Fan  
Pier  
Development

Pier  
4  
Development

### *Executive Summary*

### *Urban Design Report*

GP6 Site Access and Circulation

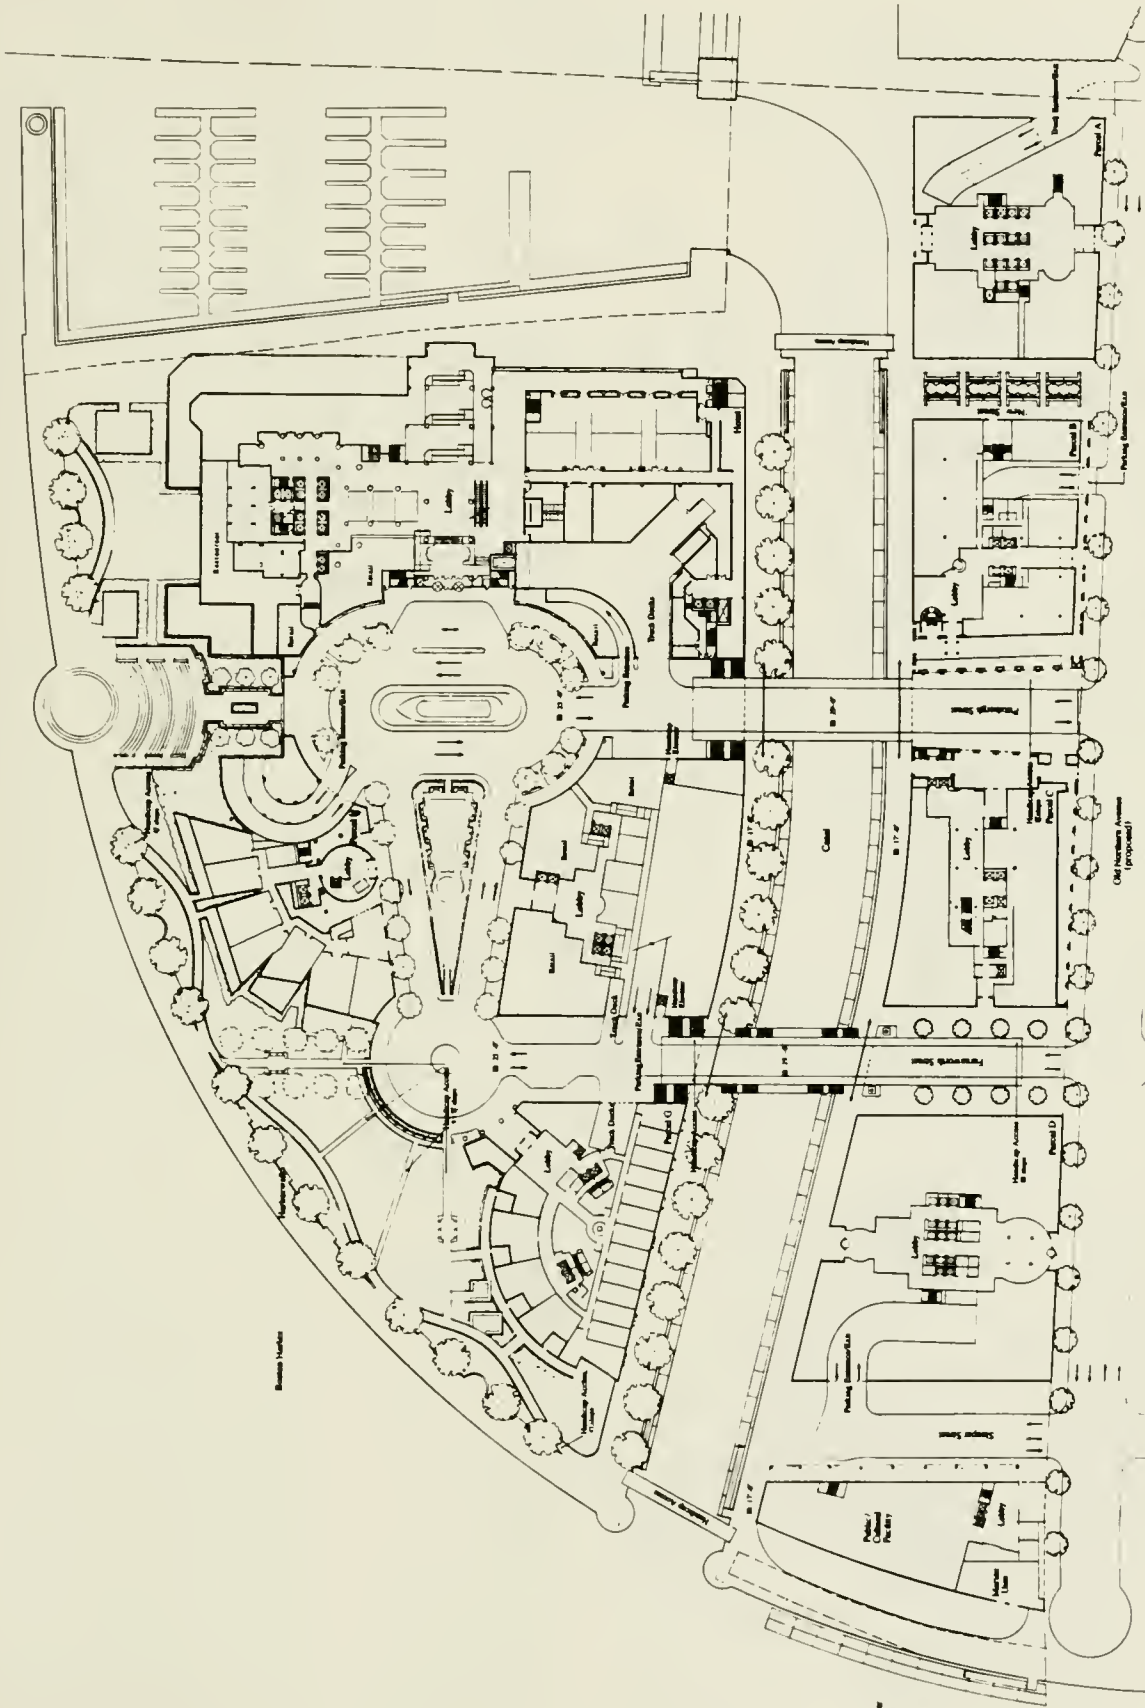
4. A new ramp has been located adjacent to the Harborwalk overlook providing barrier-free access directly from the oval to the Harborwalk. This ramp is shown on drawing GP6 included in Exhibit 1 to this report.

6. The hotel atrium has been redesigned to provide a clear and accessible public connection from the oval to the marina and breakwater. The current hotel atrium design is shown on drawing GP6 included in Exhibit 1 to this report.

4. The first floor of the hotel has been redesigned to introduce restaurant, cinema and retail functions to the street level of the hotel fronting on the oval. Restaurants and retail functions continue to line the canal and marina walks. These features are shown on drawing GP6 included in Exhibit 1 to this report.

GPII Site Organization and Comparisons

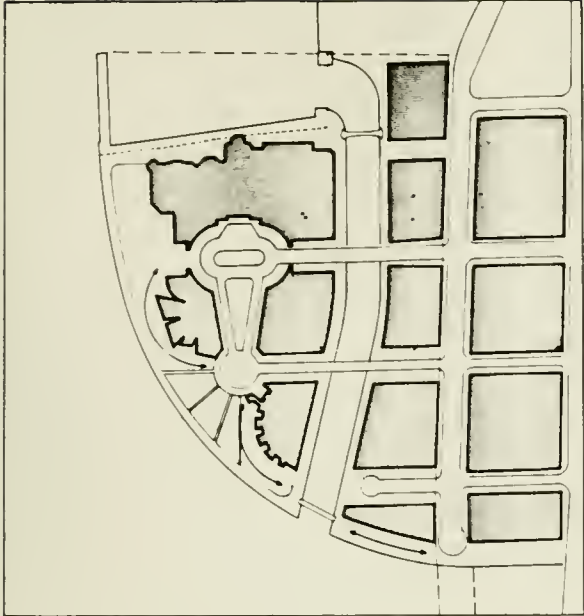
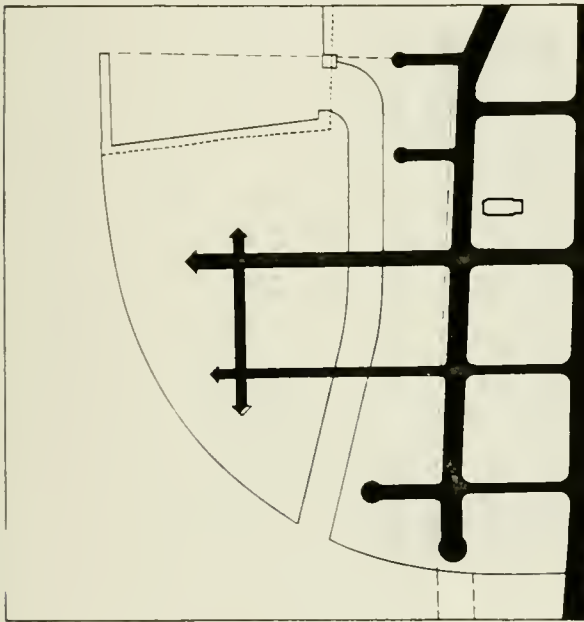
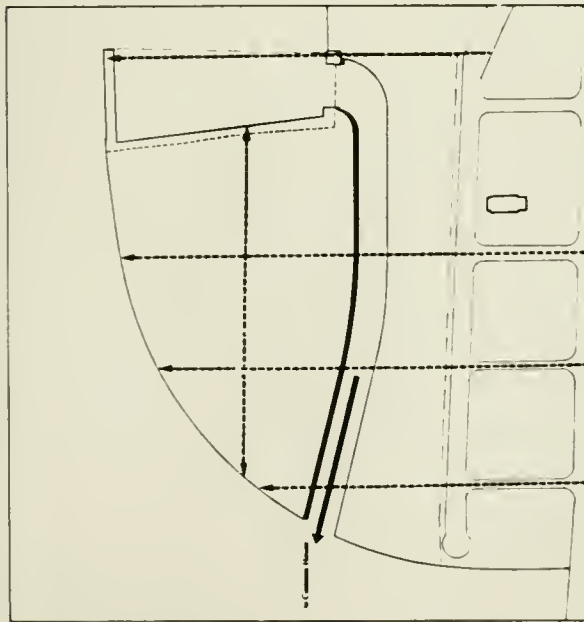
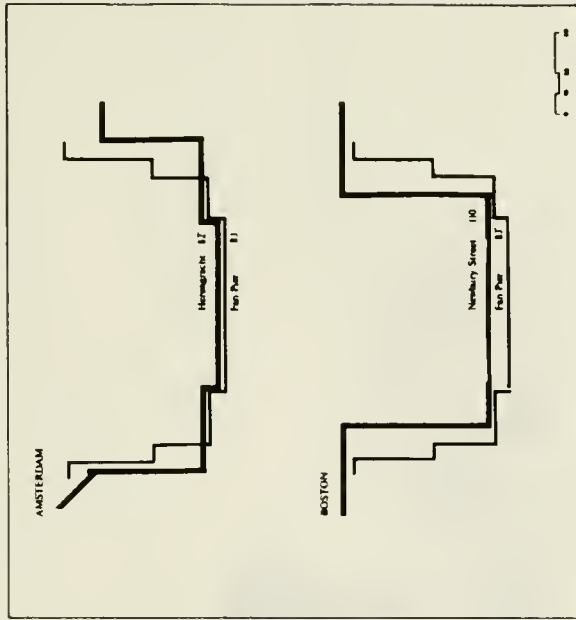
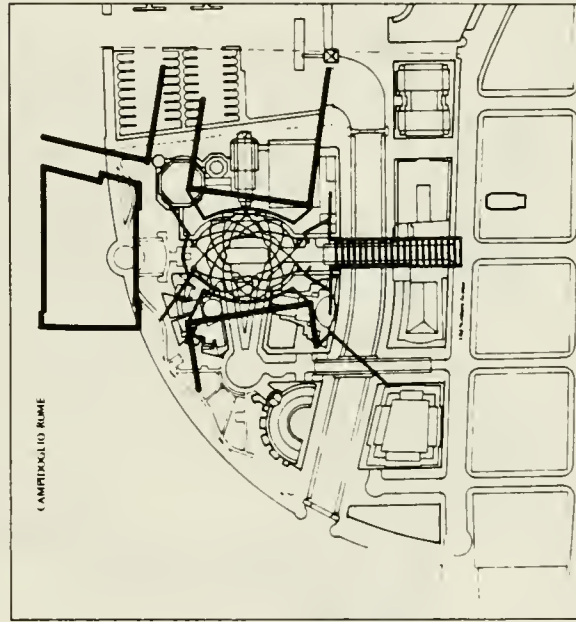
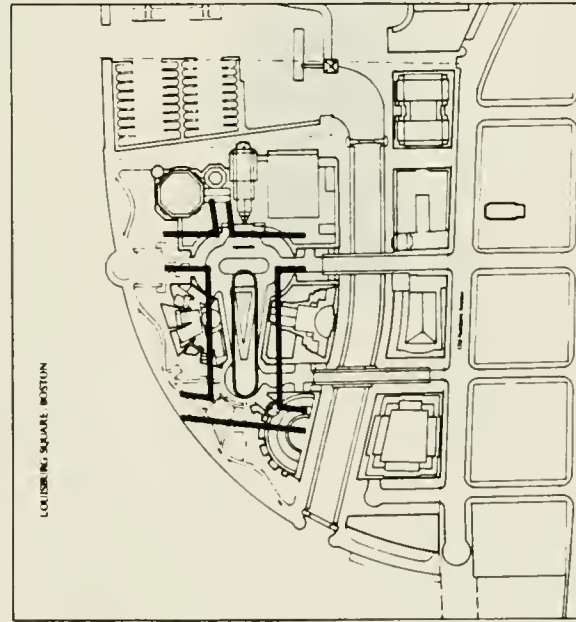
1. View corridors established by the street grid and building walls have been reinforced by the landscape design. The view corridors are shown on drawing GP11 included in Exhibit 1 to this report. Gates, paths, and trees mark and extend Farnsworth Street and the Boulevard axes to the water.
